**CN Milton Logistics Hub – Project Changes
Report (Multiple Changes)**

File: 160901330

This report has been prepared to describe a series of proposed changes resulting from refinements made during the detailed design of the proposed terminal components. Section 2.0 provides a description of the proposed Project changes, including:

CN MILTON LOGISTICS HUB - HALTON SUBDIVISION - PHASE 3 TERMINAL STORMWATER MANAGEMENT PLAN SHEET 1 OF 3											
PROJECT NUMBER				DRAWING NUMBER				ISSUE/REVISION			
60579933				04-C-1007				0

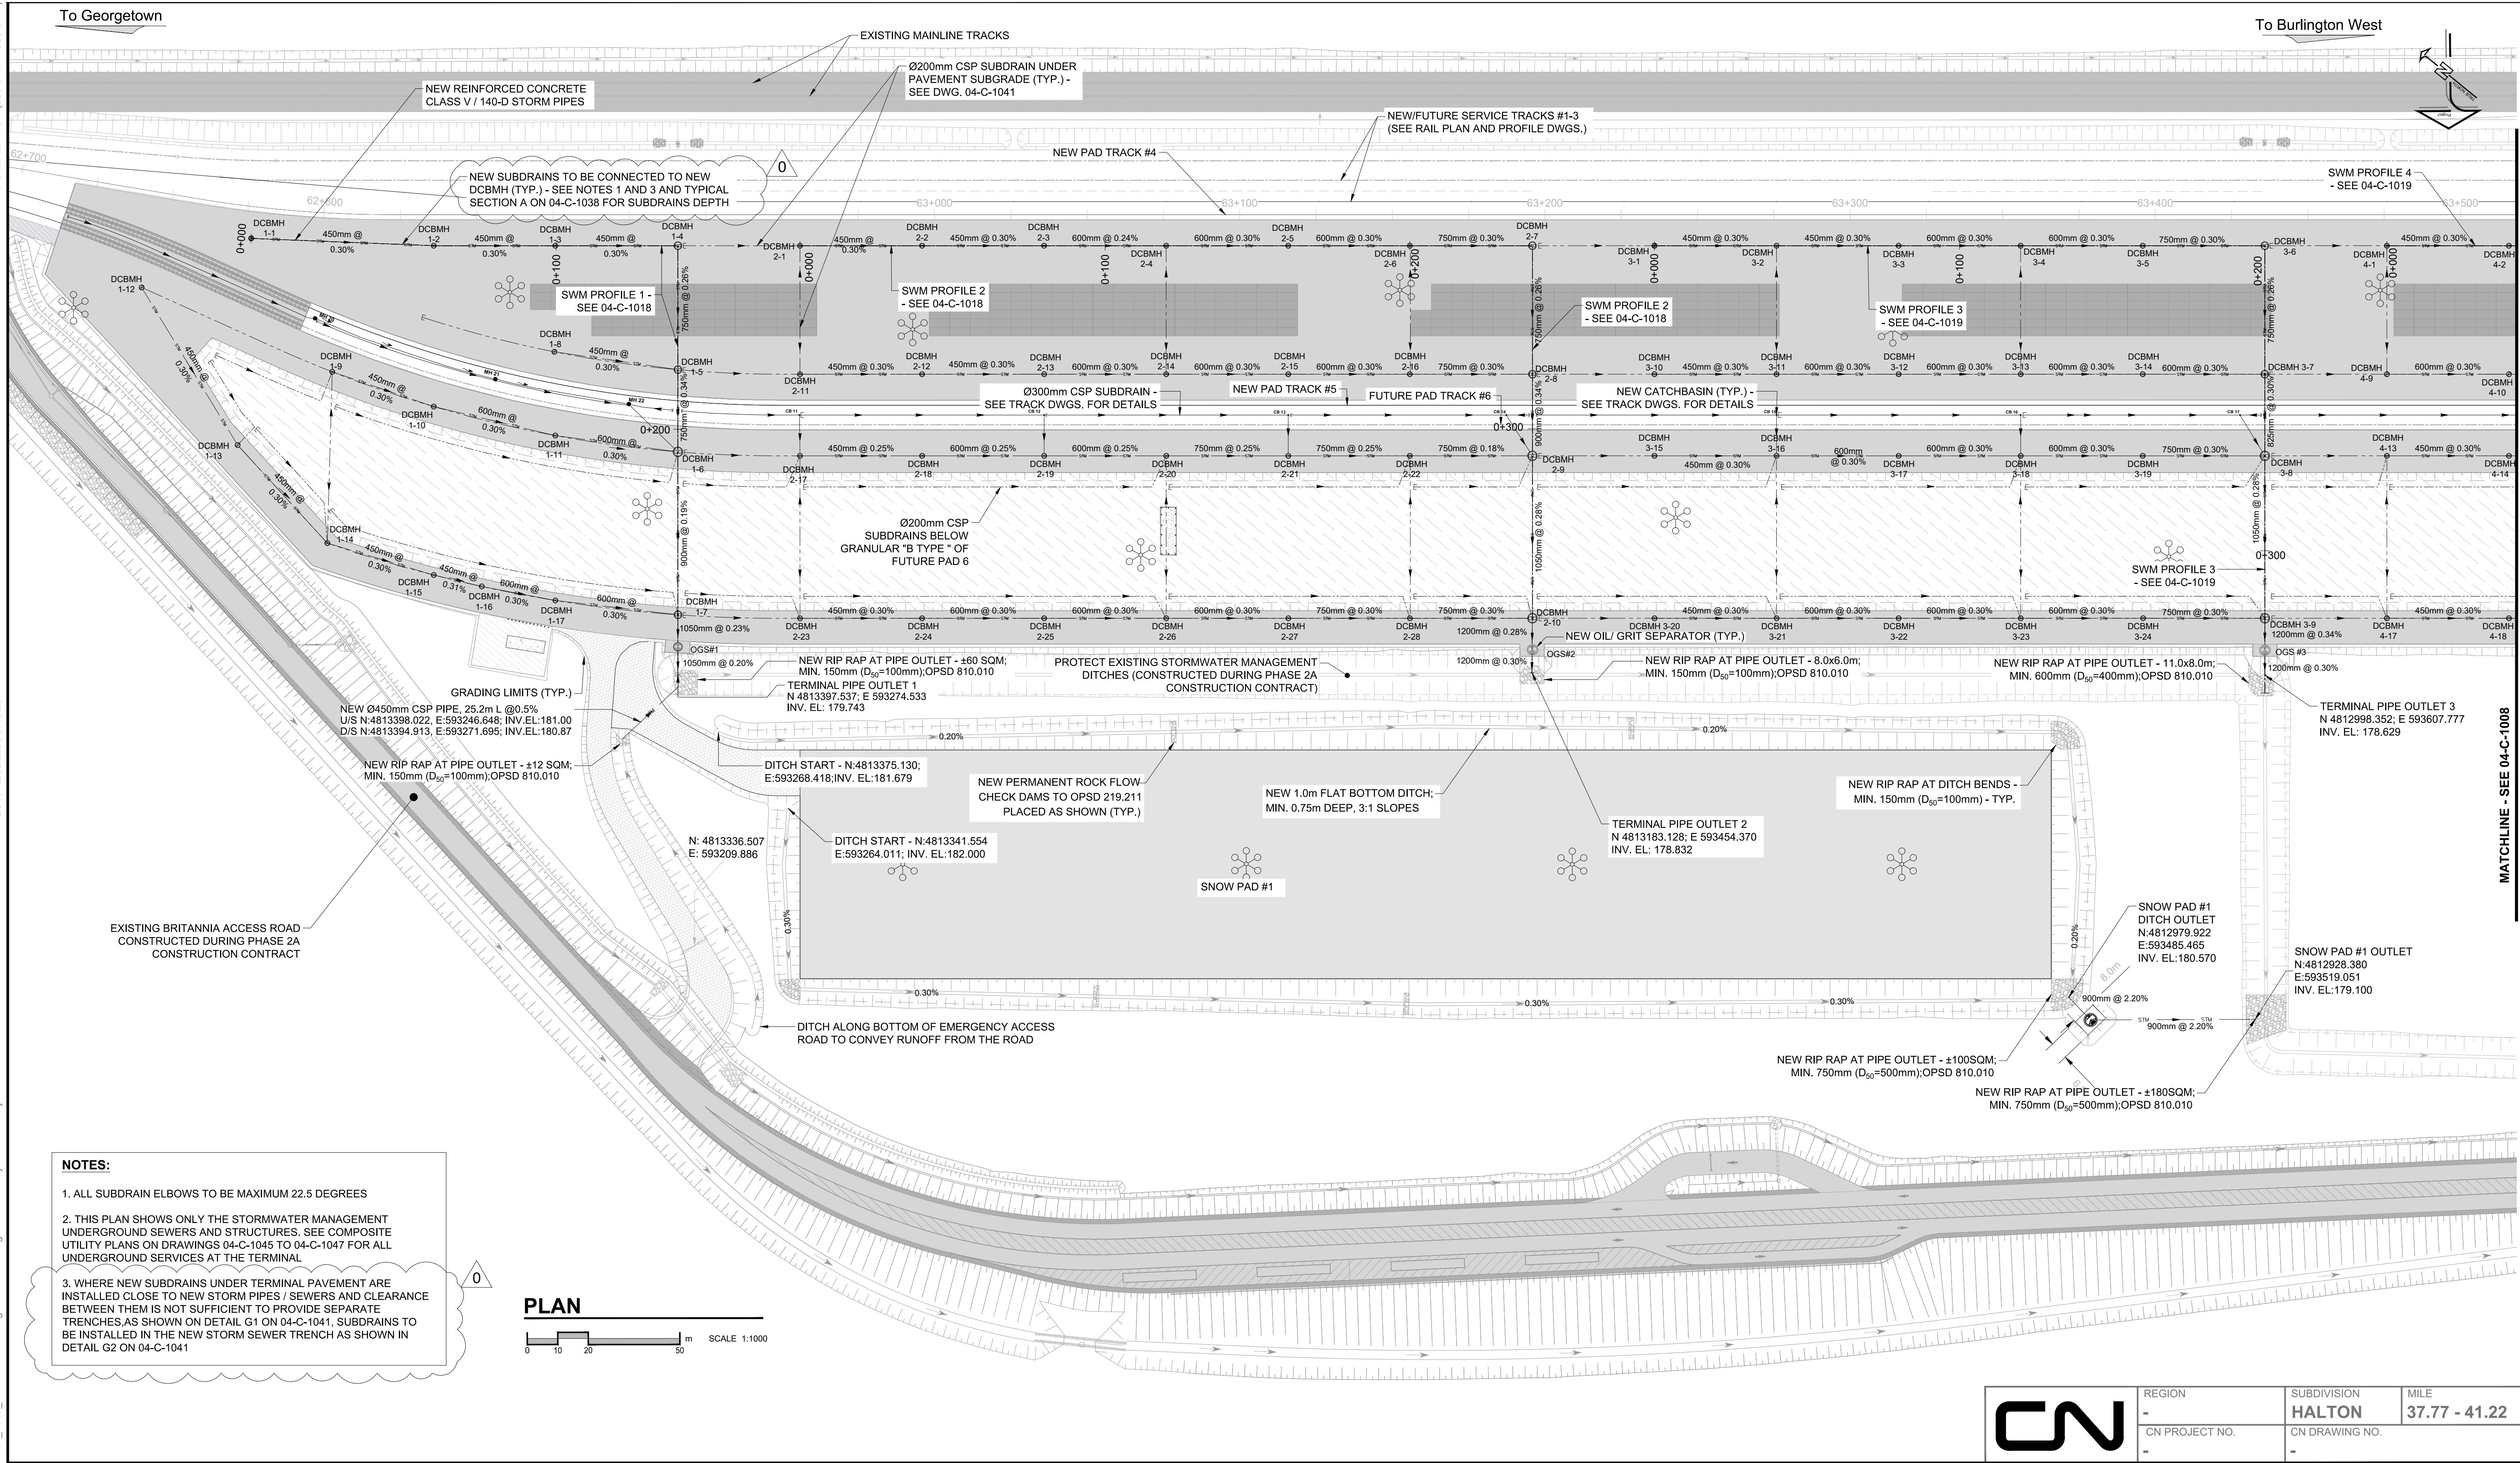
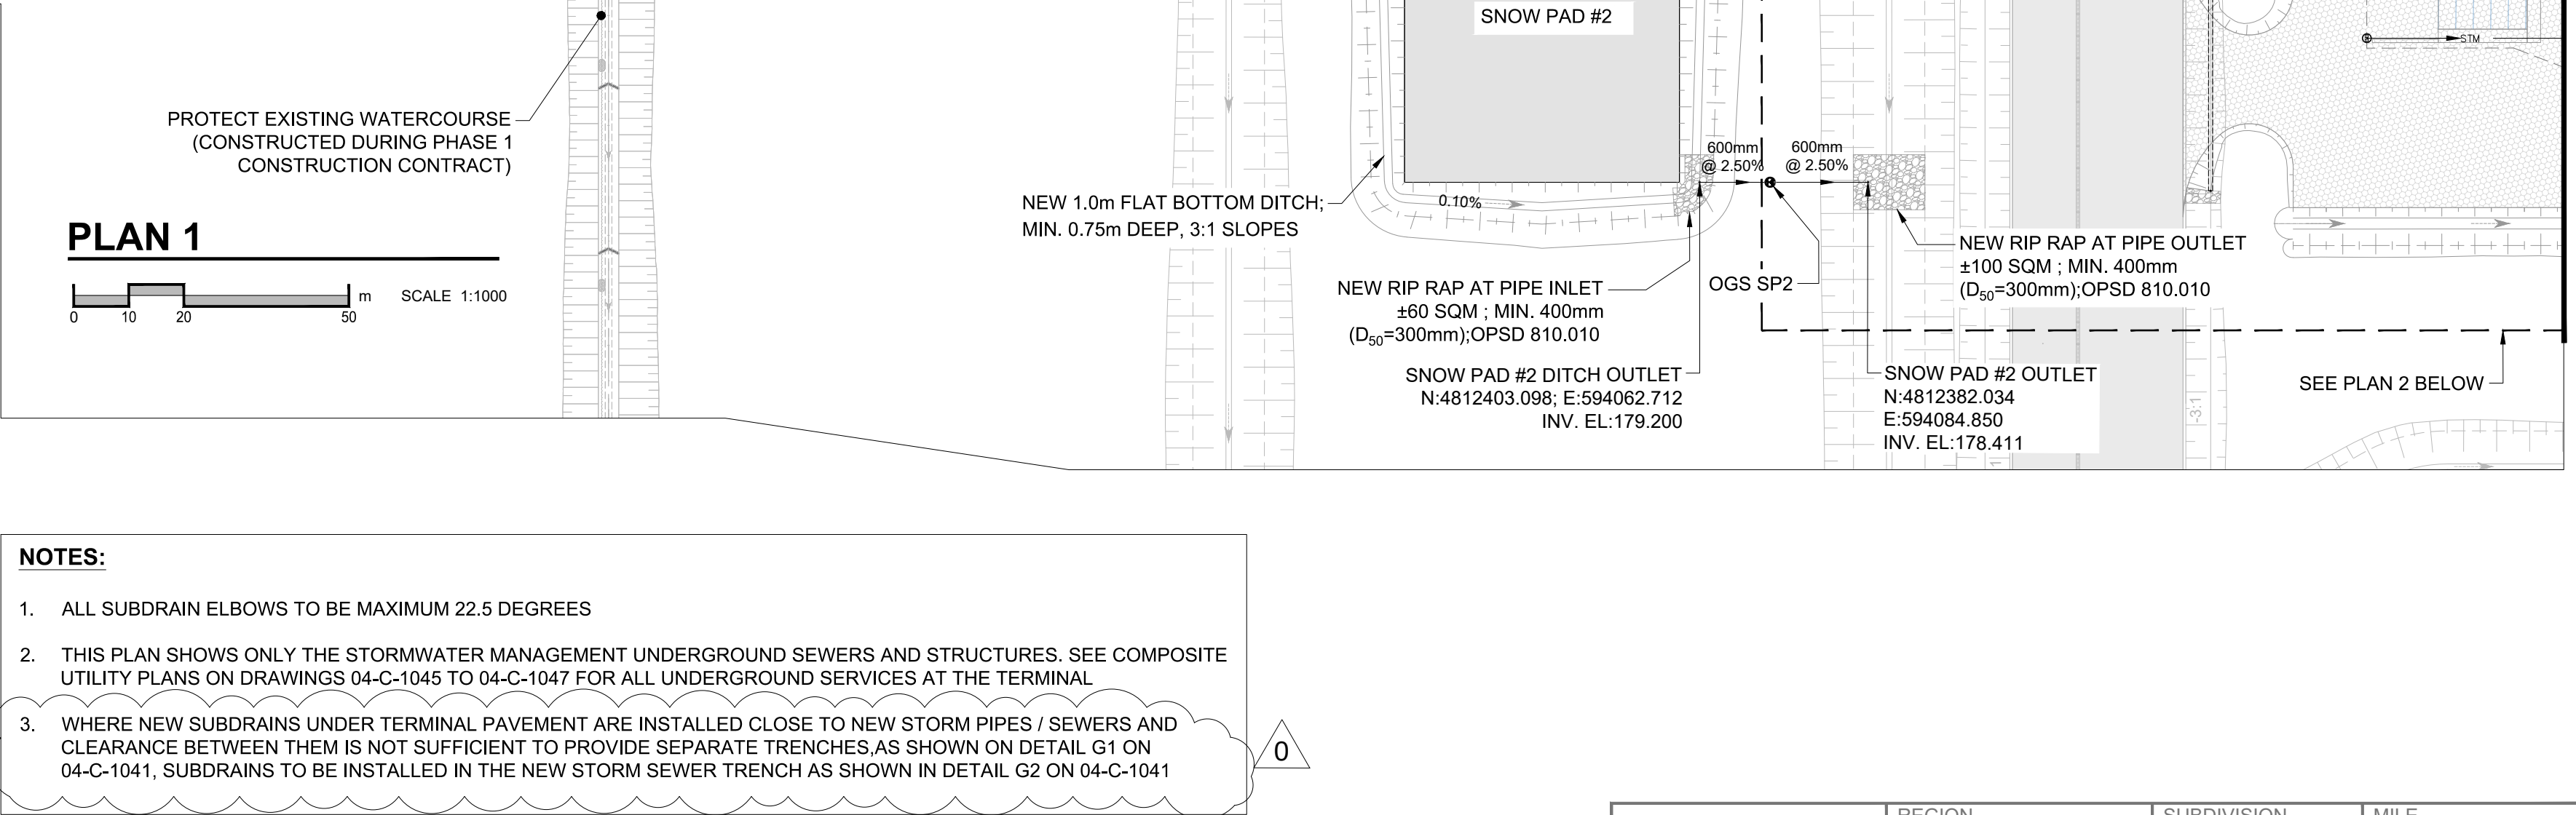
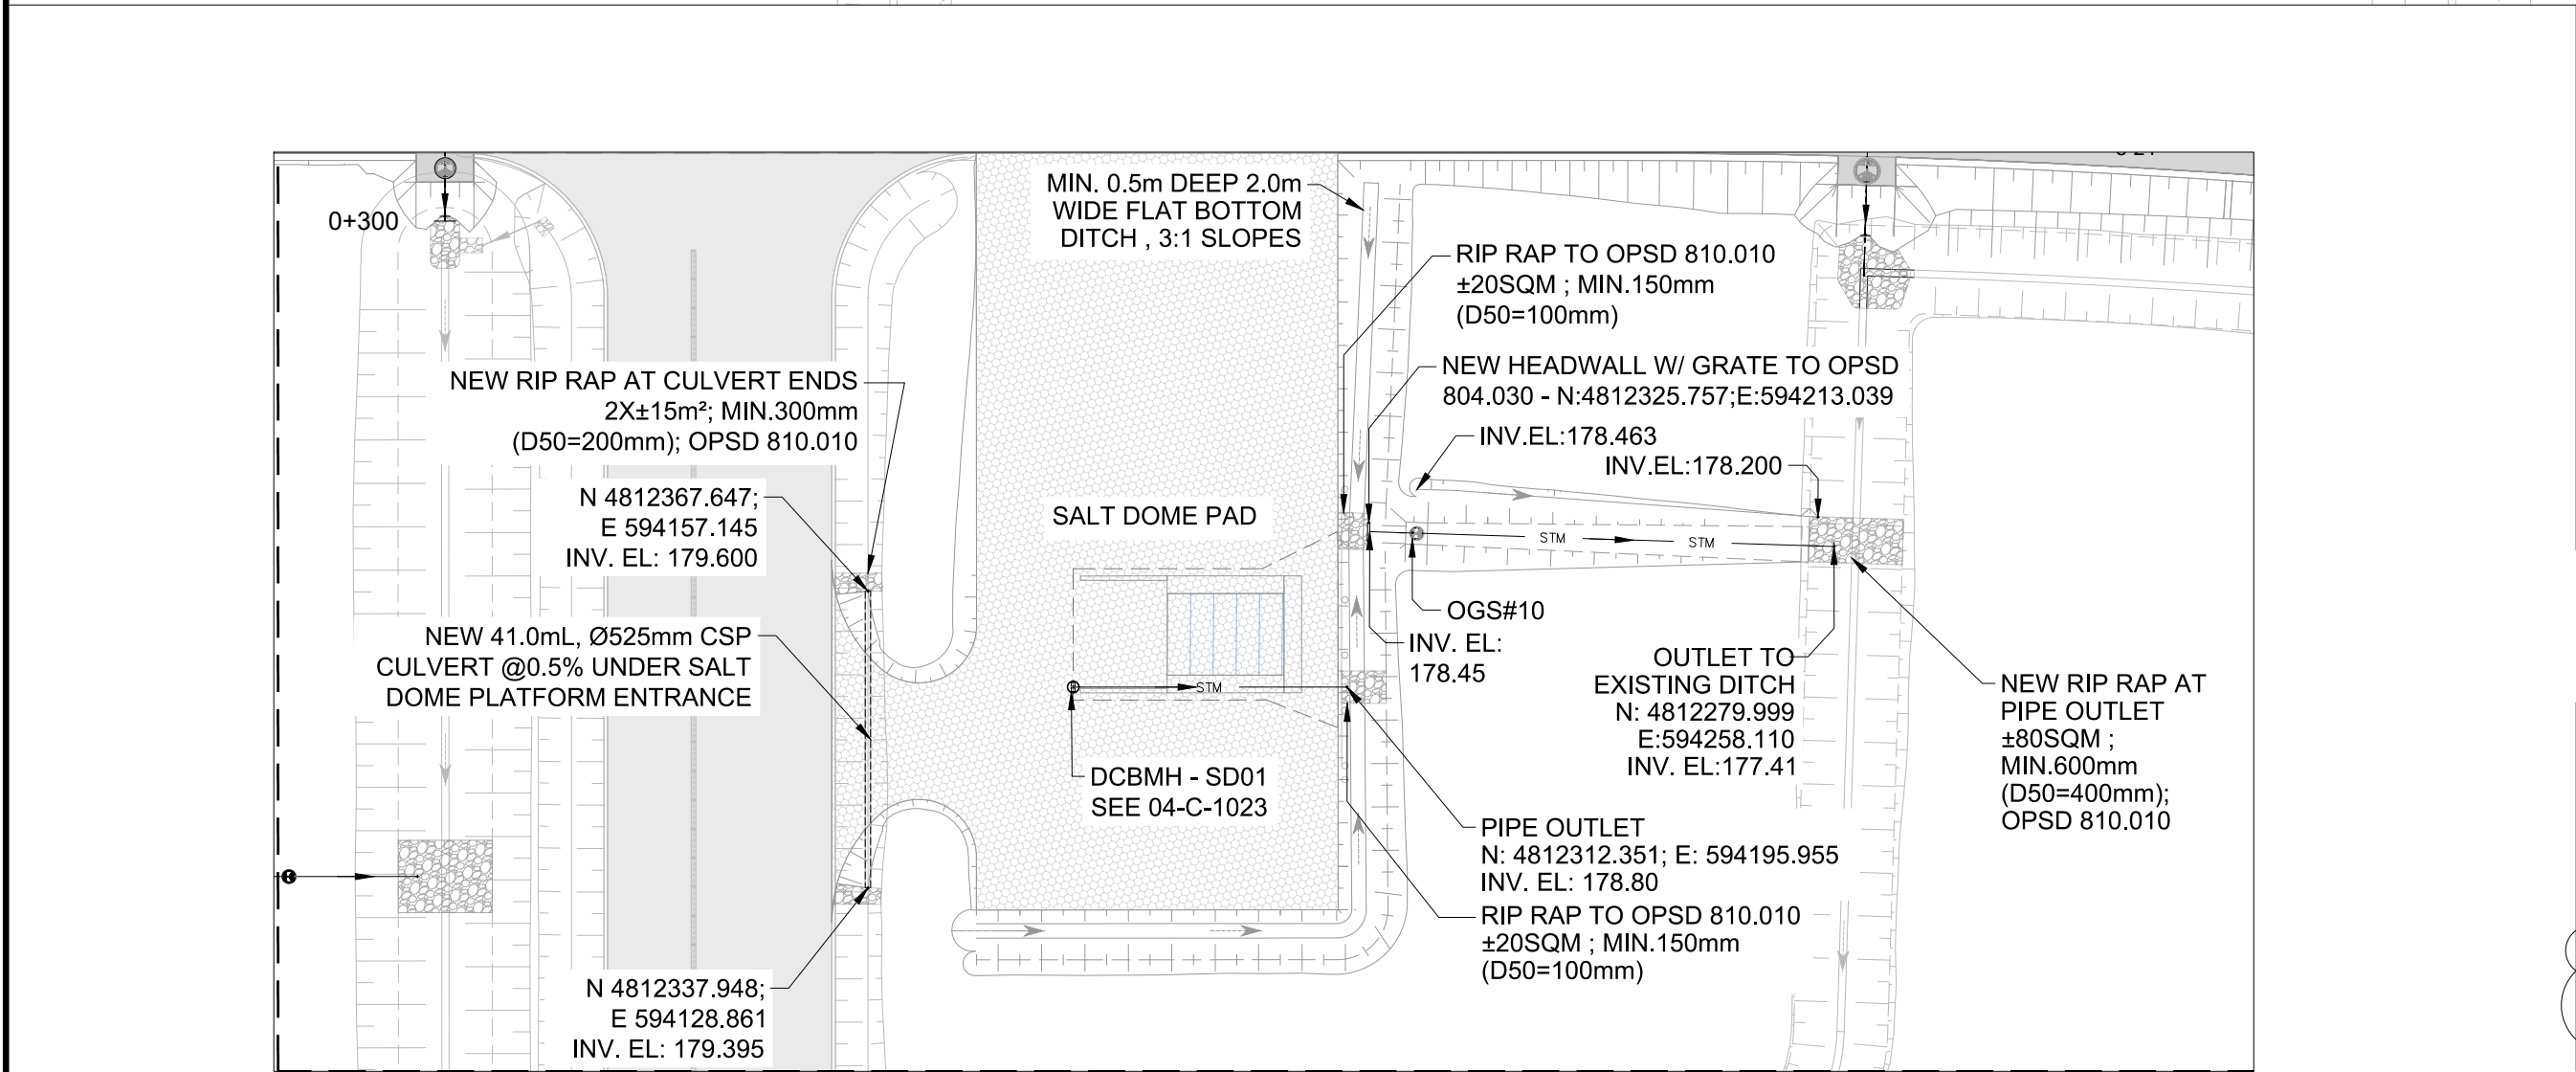
Based on this assessment, portions of previously approved work pads are proposed to be expanded to accommodate snow storage through the creation of three defined snow storage areas adjacent to the workpads. The proposed snow storage pads would consist of paved extensions of the existing work pads within the PDA, and include:

Each pad area would be surrounded by ditches designed to collect and convey meltwater and runoff to either Stormwater Management (SWM) Pond 1 or 2. The general locations of the proposed snow storage pads are shown on Figure 1 in Appendix A, with additional details provided in Appendix C.

The proposed salt storage facility would consist of a covered salt dome constructed on an impermeable pad, located within a previously identified temporary construction laydown area east of the administration building and maintenance garage. The facility would be surrounded by ditches designed to collect and convey runoff to SWM Pond 2.

The location of the proposed salt storage facility is shown in Figure 1 in Appendix A, and illustrated on the engineering drawings in Appendix C.
